U.S. Department
of Transportation
Federal Highway
Administration

In Reply Refer To: HSSD/B-69C

Thank you for your October 25, 2007, e-mail requesting Federal Highway Administration (FHWA) acceptance of a minor modification to your company's Variable Length Barrier (VLB) elements of the Reactive Tension Quickchange Moveable Barrier System as a Test Level 3 device for use on the National Highway System (NHS). You requested that we find this device acceptable for use on the NHS under the provisions of National Cooperative Highway Research Program (NCHRP) Report 350 "Recommended Procedures for the Safety Performance Evaluation of Highway Features."

TITLE: 18" RTS VLB-NO SPRING
1/4" SHELL

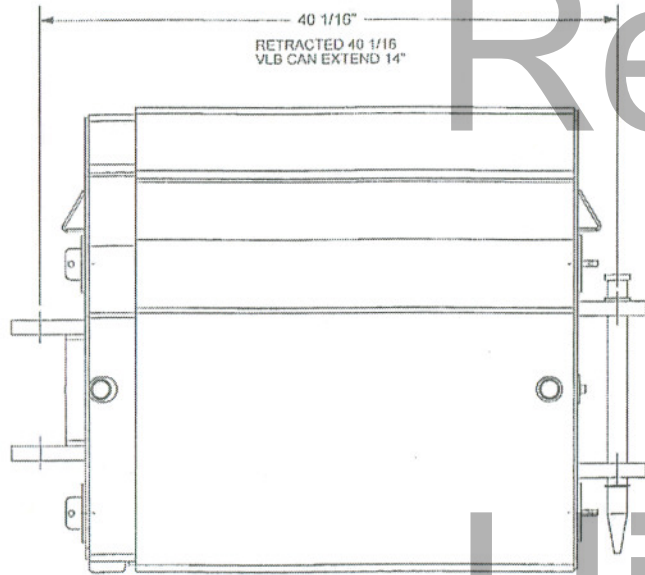
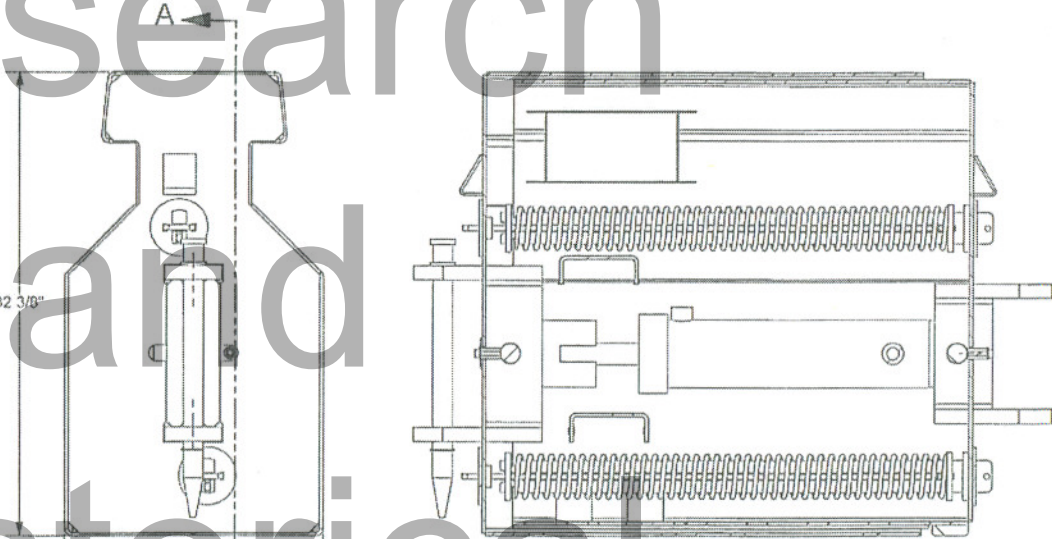
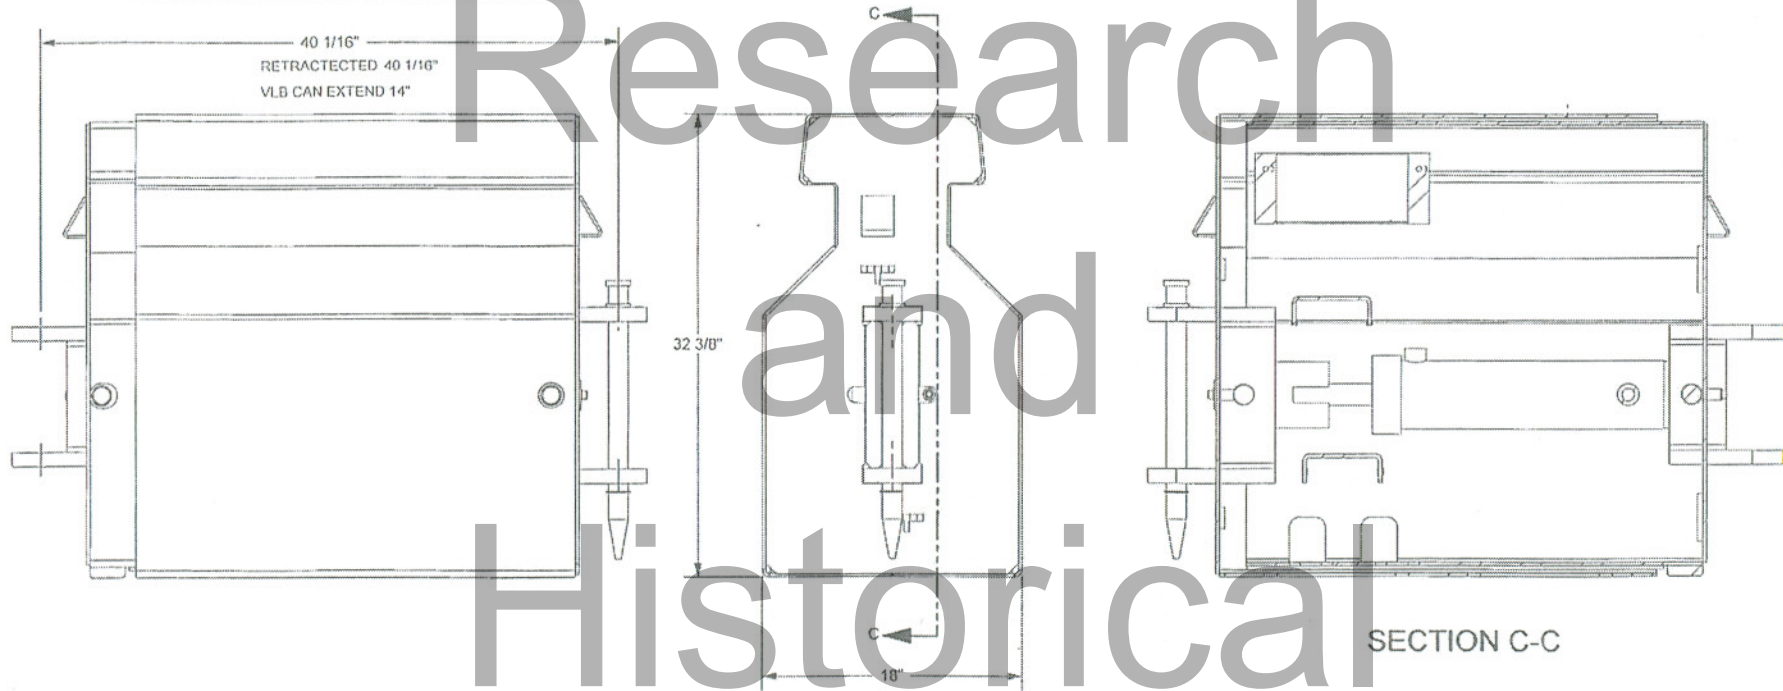
Our letter B-69 dated June 27, 2000, found the Steel Reactive Tension System (SRTS)/Concrete Reactive Tension System (CRTS) acceptable for use. You propose to remove the spring from the VLB segments as they have been found to be unnecessary for the proper operation of the Reactive Tension Barrier. We concur with your conclusion that the removal of the springs in the VLB units will not affect the impact performance of the system and the Reactive Tension Quickchange Moveable Barrier would be expected to perform in a similar manner to that indicated in the FHWA acceptance letter for this product.

Therefore, the system described above and detailed in the enclosed drawing is acceptable for use on the NHS under the range of conditions the RTS was tested, when proposed by a State agency.
